Access Compliance Report Public Rights-of-Way (Curb Ramps)

Main Street: MACMURRAY_ST Cross Street: SYRACUSE_AVE Location: SW

ADA ID: RPRK210921151300 Ramp Type: Type 1 - Perpendicular Diagonal Initial Pass/Fail: Pass Overall Compliance: No Severity Score: 10

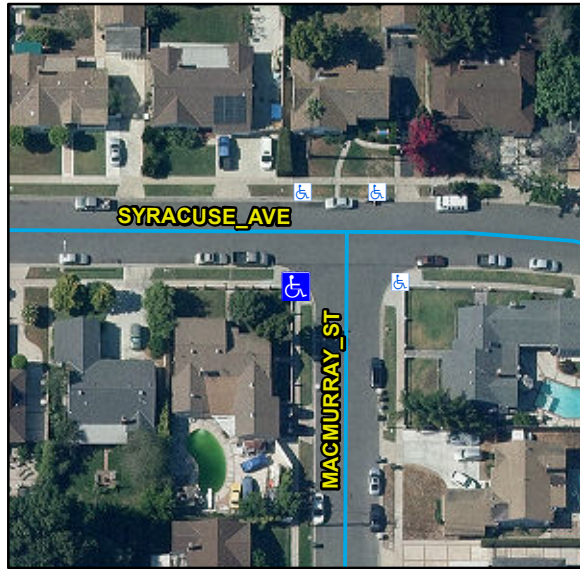
R304.2.2, R204.3, R304.2.1, R304.2.2-Perp, R304.3.2-Para, R304.5.3, R302.7, STD 1115

Remove & Replace Curb Ramp With Two New Directional Ramps or Equivalent. Remove & Replace Gutter.
